Docket Number:	03-AFC-02C
Project Title:	Los Esteros Phase II Compliance
TN #:	229305
Document Title:	Los Esteros Critical Energy Facility Responses to Staff Data Requests Set 2.A1-A6 and Minor Revisions to Proposed Modification
Description:	N/A
Filer:	Eric Janssen
Organization:	Ellison Schneider Harris & Donlan LLP
Submitter Role:	Applicant Representative
Submission Date:	8/9/2019 12:51:23 PM
Docketed Date:	8/9/2019

RE: Los Esteros Critical Energy Facility (03-AFC-02C): Energy Storage
Amendment-- Responses to Staff's Data Requests, Set 2, A1 through A6 and
Minor Revisions to Proposed Modification

MINOR REVISIONS TO PROJECT DESCRIPTION

ATTACHMENT A

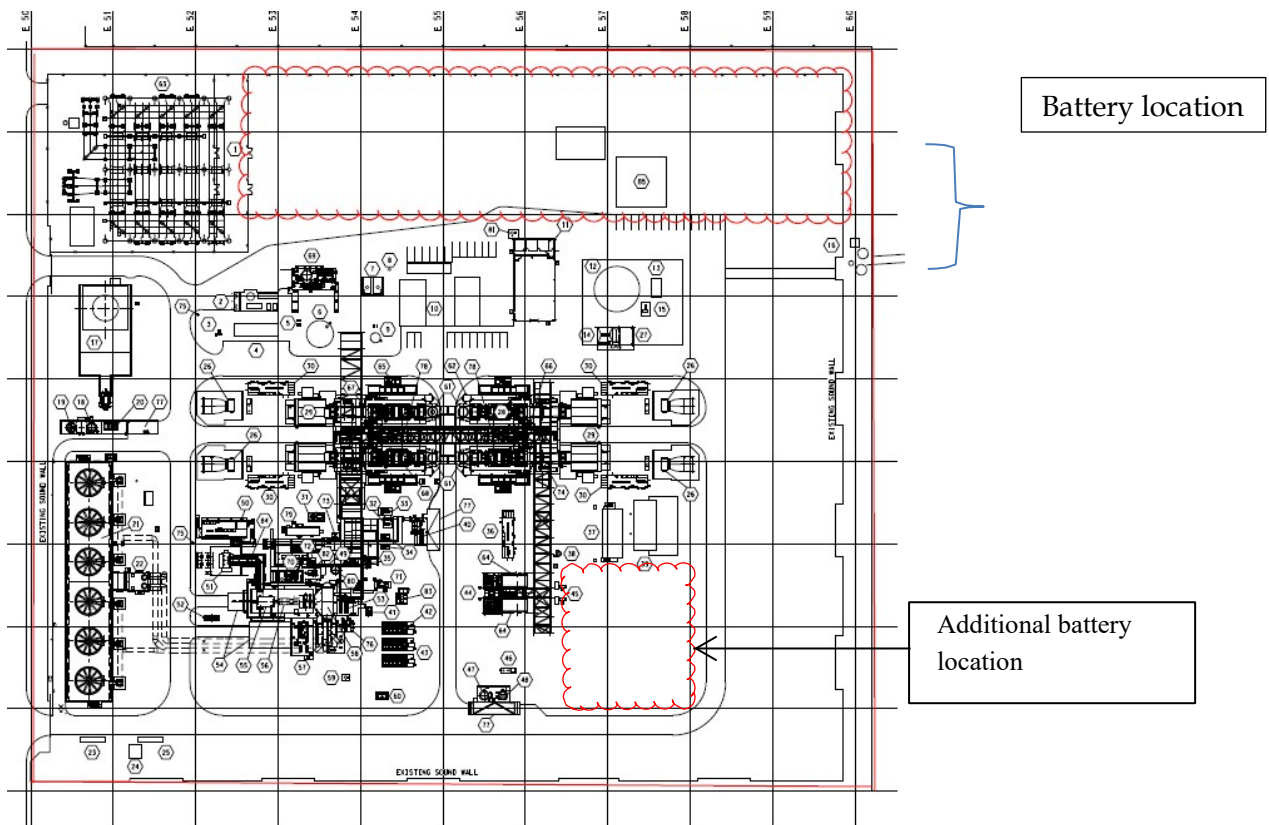
Page 2-1 of the Petition for Modification submitted by the Project Owner (TN#: 221243-2) provides the proposed location for the battery energy storage system (“BESS”). To provide additional flexibility in the location of the BESS, the Project Owner proposes to add an additional potential location for either all or some of the BESS components. This additional area is located south of the power distribution center, and is an approximately 150-foot by 150-foot area currently covered with rip rap. The additional potential location is depicted in Attachment A.

This section includes a description of the proposed project modifications, consistent with CEC Siting Regulations (Title 20, CCR, Section 1769 (a) (1) (A)). The battery installation will be located on the north end of the existing property east of the switchyard inside the fence line. The project map below indicates the area that the batteries will be located. The project includes ~~a three (3) megawatt (MW) battery energy storage system (BESS) –an installation of up to 6 MW vanadium flow battery, with up to 18 MWh of energy storage capability, and/or an additional installation of up to 6 MW utilizing either titanium-manganese flow batteries, lithium-ion (Li-ion) batteries~~ Battery, or a combination of both. ~~with up to 6 MWh of energy storage capability.~~ These energy storage systems are The BESS is comprised of the storage device, the interconnection and the communication system. The system layout will be ~~approximately 167 ft. wide x 112 ft. length and approximately 20 ft. in height.~~ The energy storage system will be located on a concrete foundation with secondary containment. The potential locations for the BESS are depicted below.

FLOW BATTERY SYSTEM 3MW × 3h									
CONTRACT NO. :					EQUIPMENT NO. :				
DWG TITLE :							DRAWING NO.		
EQUIPMENT LAYOUT DRAWING									
APPROVED	CHECKED	DESIGNED	DRAWN	SHEET	OF	REV	SCALE	DATE	
				1			—

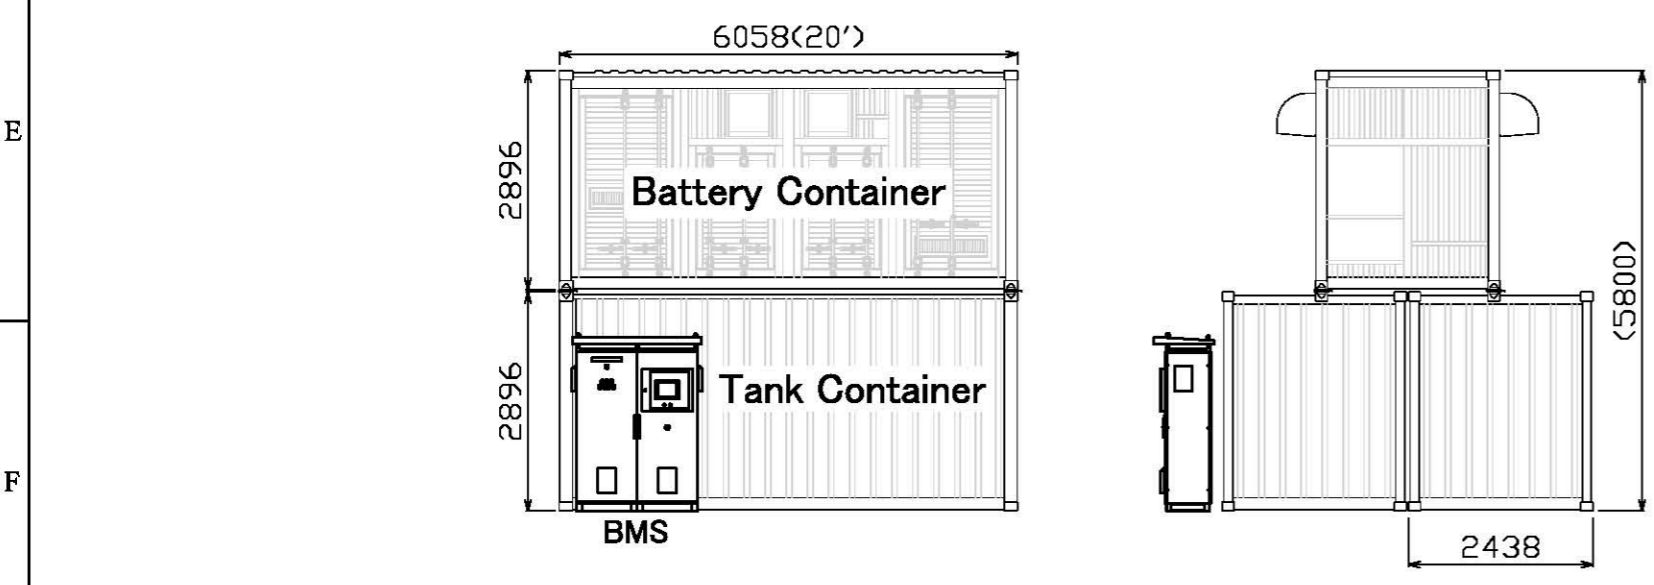
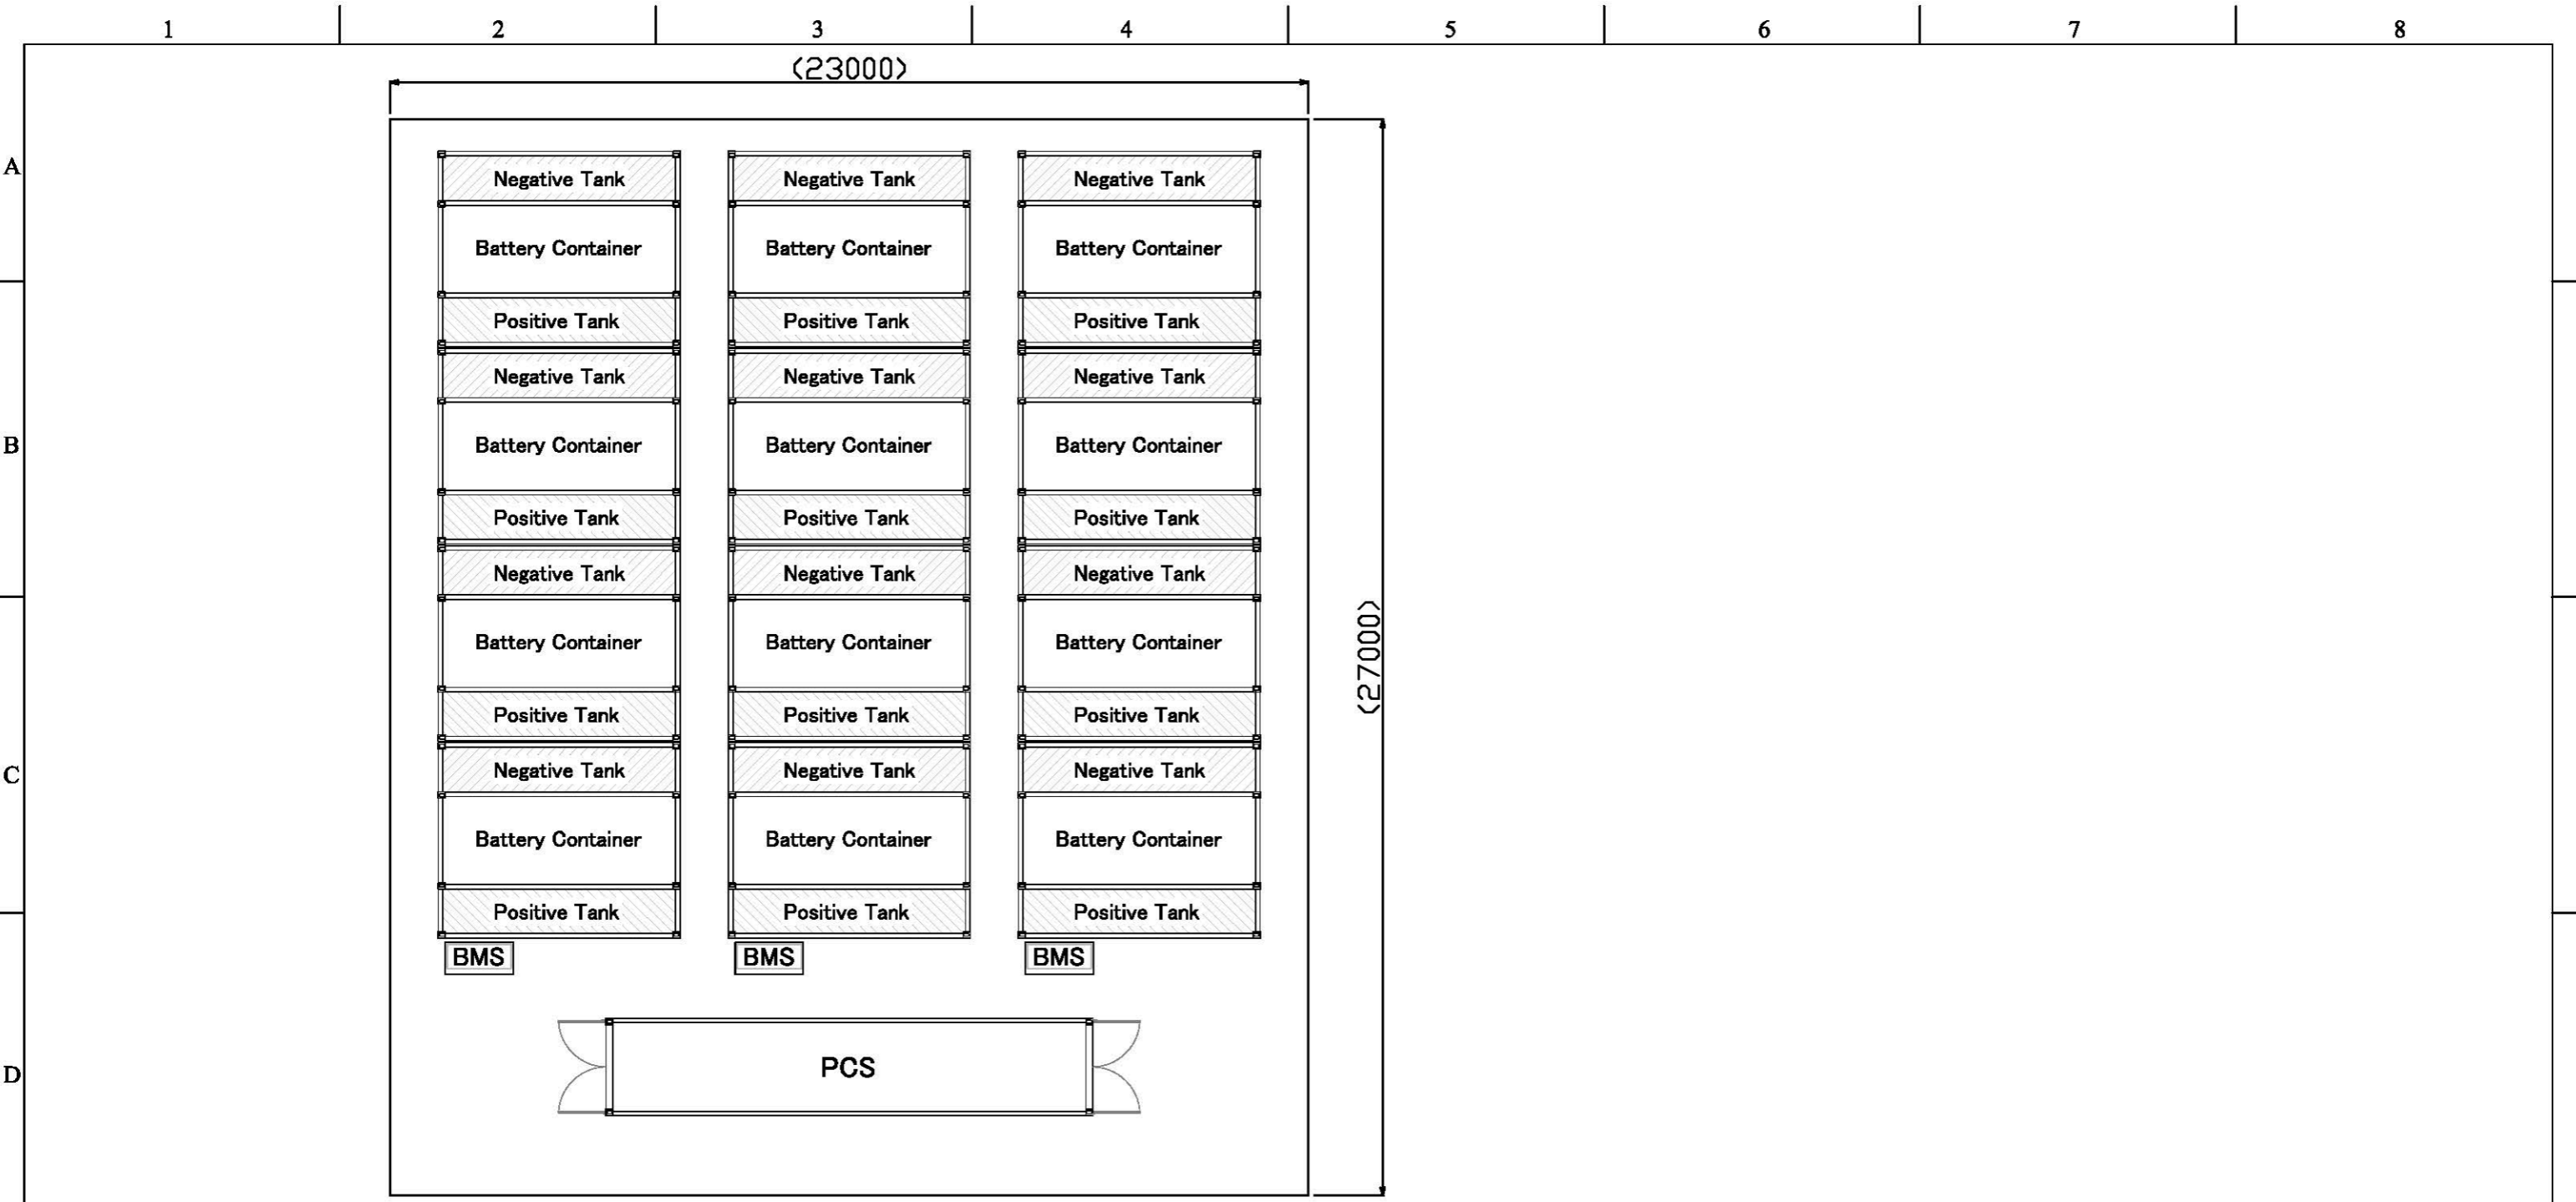
A3. Please provide a preliminary drawing showing the configuration of the titanium manganese flow battery installation. Please clearly label the location of the negative and positive electrolyte tanks.

RESPONSE: The Project Owner proposes installation of a 3MW BESS, with up to 18 MWh of energy storage capability, which would consist of approximately 12 battery containers (20 ft), 24 tank containers (40 ft), one PCS container (40 ft) and one BMS cubicle. The BESS will utilize either titanium manganese flow batteries, lithium ion batteries, or a combination of both. Potential configurations of the titanium-manganese flow BESS are provided as Attachment B.

RESPONSE: Please see Attachment B.

Figure 1. Appearance of battery system

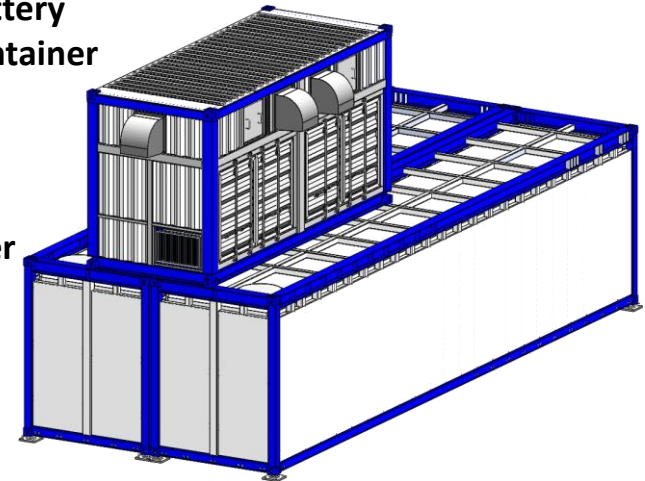
A4. Please explain how secondary containment would be provided for the negative and positive electrolyte tanks, and whether potential mixing of positive and negative electrolytes in a secondary containment would be a problem due to incompatibility.

- Electrolyte leakage will be detected by mechanical (float sensor) or electrical (insulation monitoring) devices.
- The float sensors will be installed in the each battery and tank container.
